**APPLICATION FOR
URBAN DESIGN COMMISSION
REVIEW AND APPROVAL**

PROJECT ADDRESS: HILLDALE REDEVELOPMENT, 702 MIDVALE
ALDERMANIC DISTRICT: 11

Re: 702 North Midvale Boulevard
Hilldale Redevelopment
Alterations to Previously Approved SIP - Building M
EUA Project No.: 106360-01

This application proposes that the stucco material shown on Building M (subsequently named 'The Heights') be changed to EIFS.

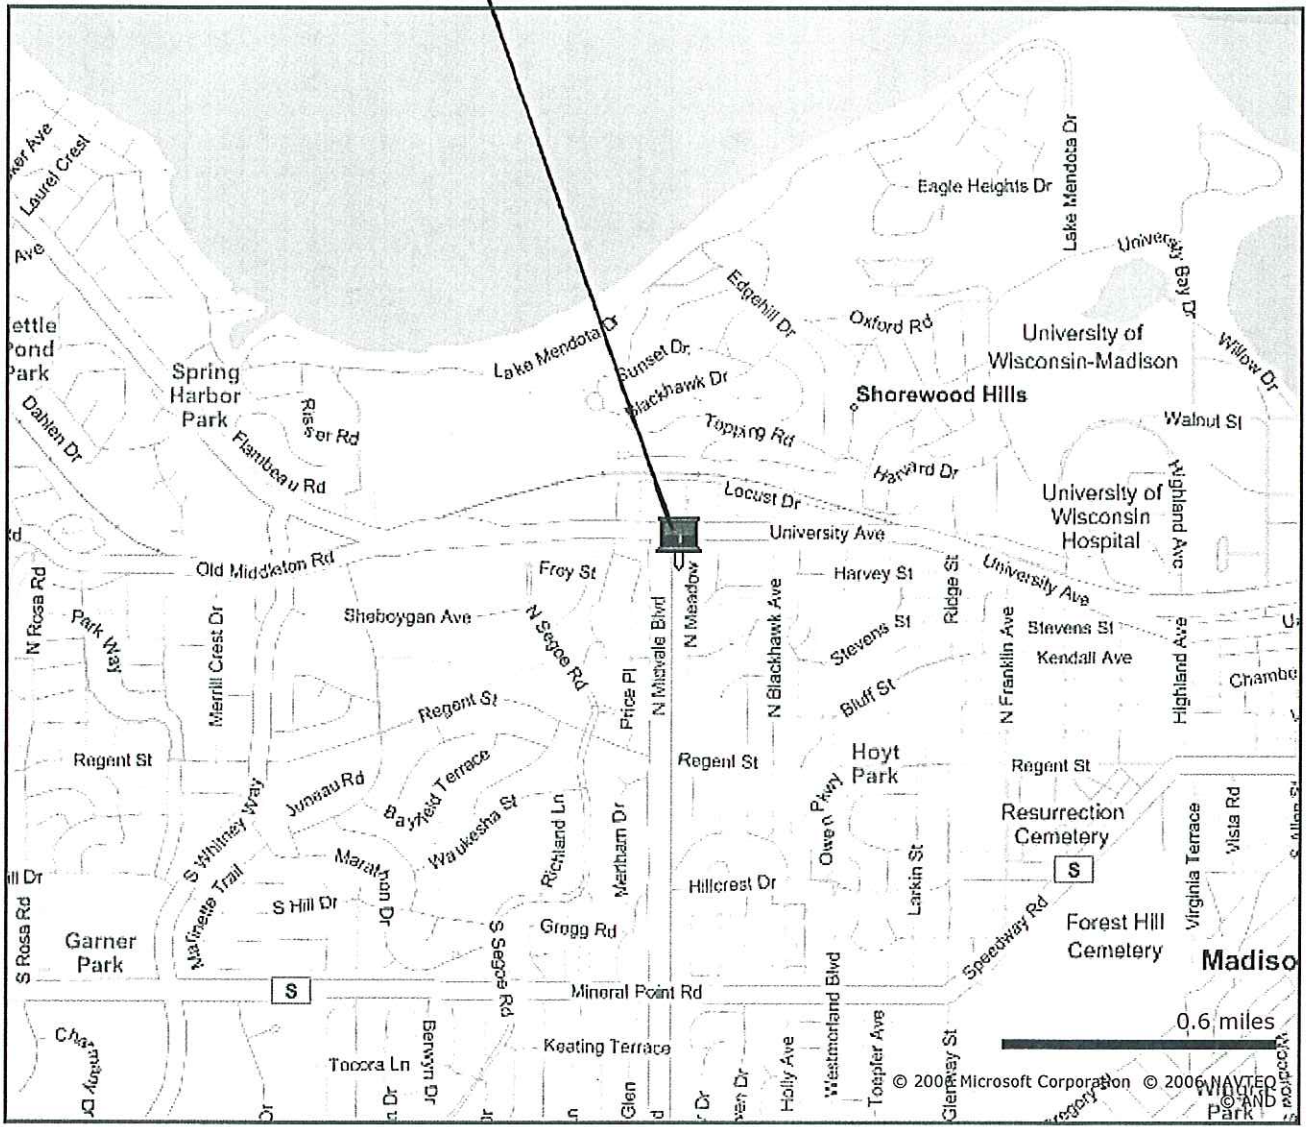
Therefore, this application requests approval to substitute the stucco for an EIFS product:

- The EIFS system does not require metal framing to support the finish layers
- The EIFS system will comprise only 12% of the total building envelope area
- The base coat, mesh and polymer based exterior finish coat for both stucco and EIFS are the same product.
- The color and texture of the EIFS system will be identical to the approved design.
- A heavy-duty impact resistant mesh will be provided at balcony walls below four feet to improve the durability of the product at contact areas.

WALL MATERIALS

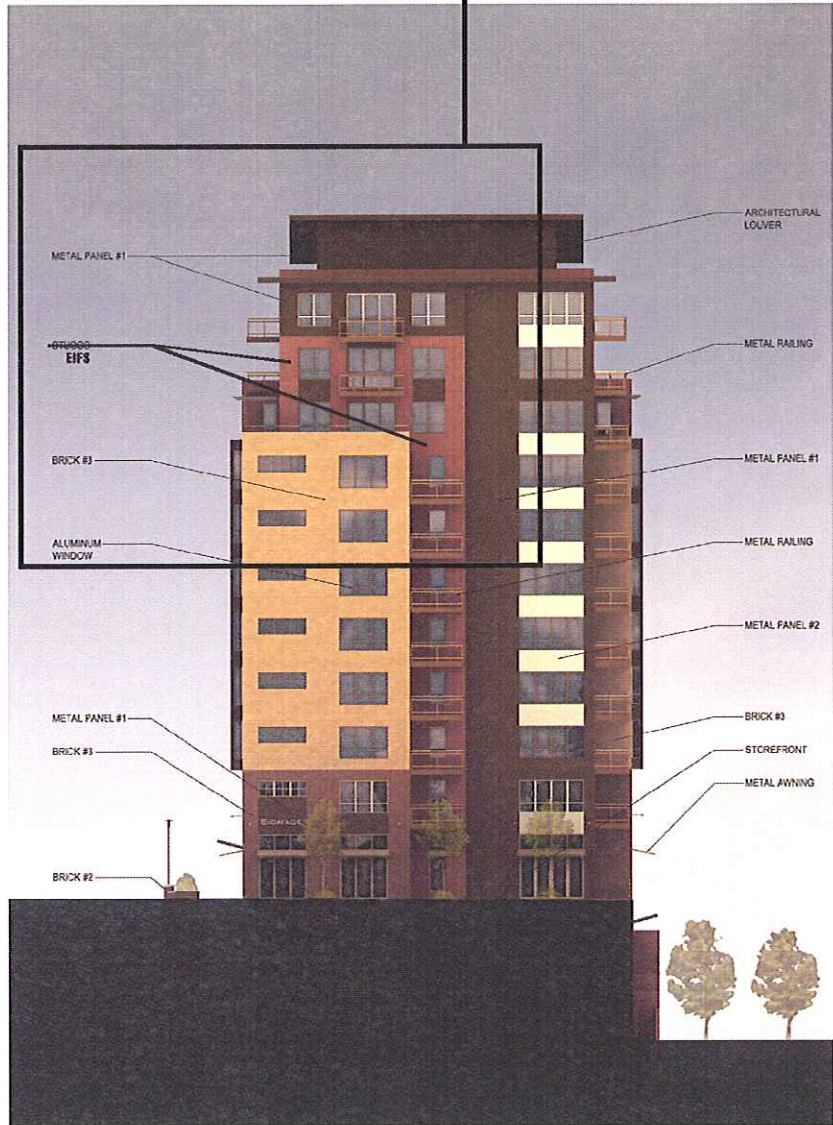
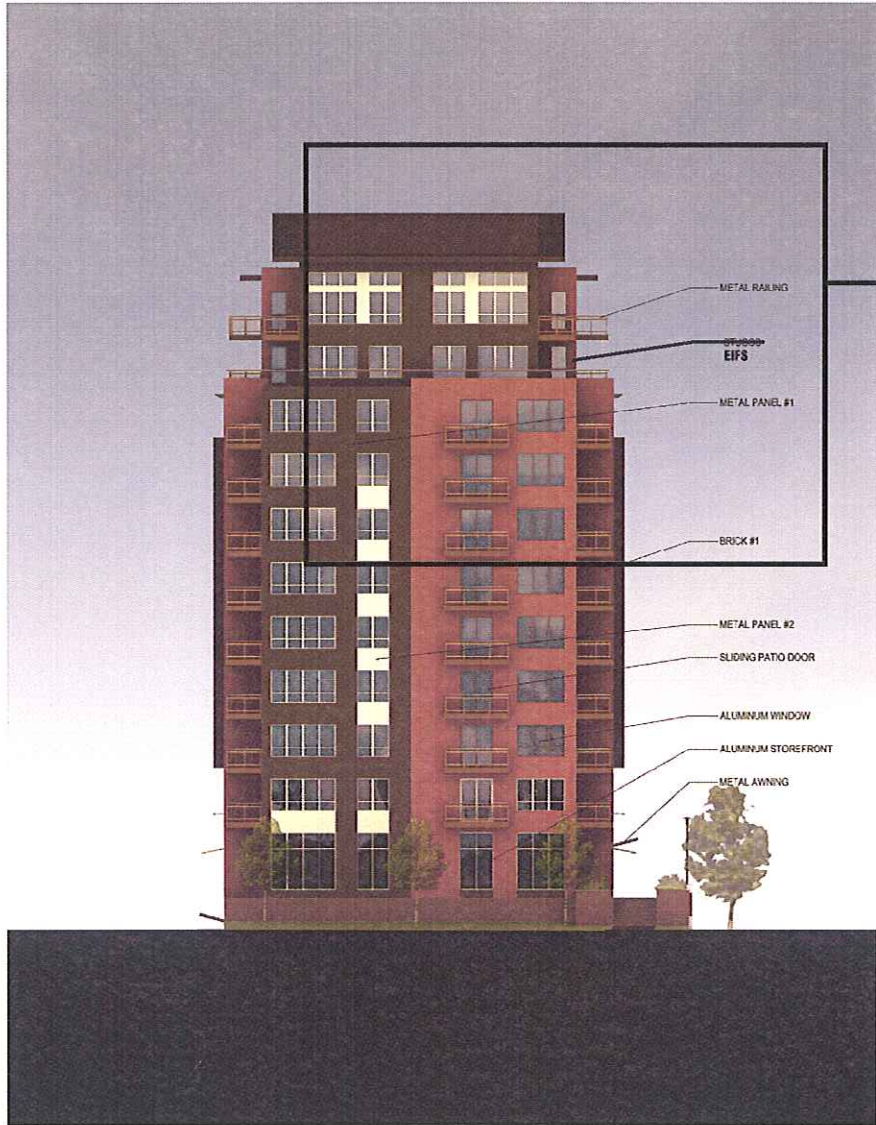
Brick	39%
Windows	32%
Metal Panels	17%
EIFS	12%
Total	100%
